John Hickman - Response to Questions in Email Dated 2/6

NRC Comments/Questions for Four FSSRs
Email from Hickman to Carson dated 2/6/2007

00L-17-01

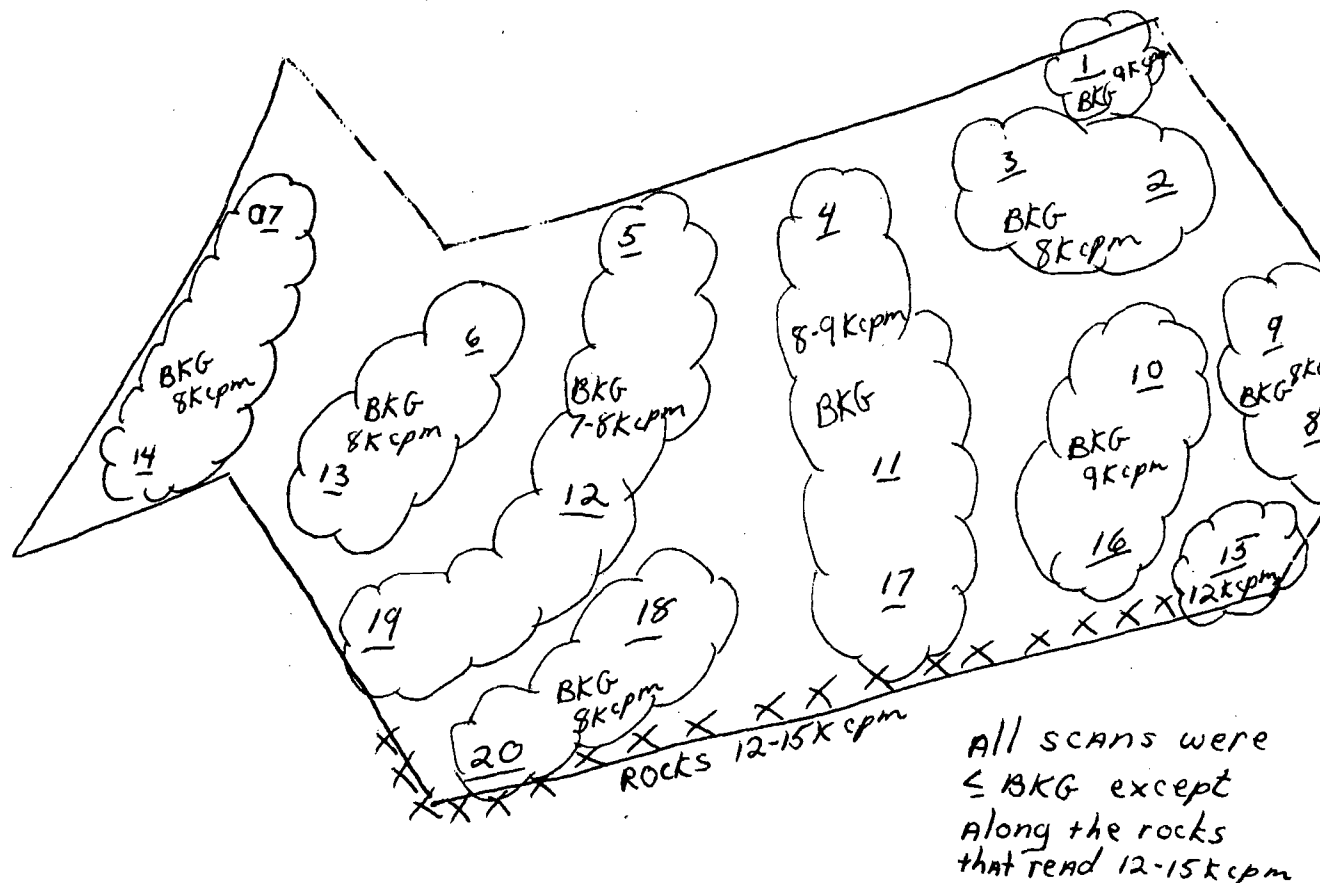
Also, YR does not indicate the locations where SPA-3 scan surveys were made in Class 2 or 3 survey units. Does the YR applicable QA Plan or the LTP direction indicate the information that needs to be recorded in survey records?

The FSSP for OOL-17 indicates that in addition to scanning a 1 m radius footprint surrounding each sample point before taking the sample, scan areas should be biased to high traffic areas and areas indicating drainage collection. Although LTP Section 5.8, does not specifically require that a map of scan areas be included in the FSSR, the locations of scans are maintained in detailed FSS backup data. A daily survey journal is prepared and maintained in accordance with site final status survey procedures. This includes information such as: the sample's name, the sample location with sufficient description of measurement locations to allow the location to be identified in the future (if applicable), measurements or samples collected at the sampling site (area scan, soil sample, etc.), and any deviations from the FSSP required by field conditions. An example of a map of scan areas included in the daily survey journals (in this case for OOL-17) has been included as an attachment.
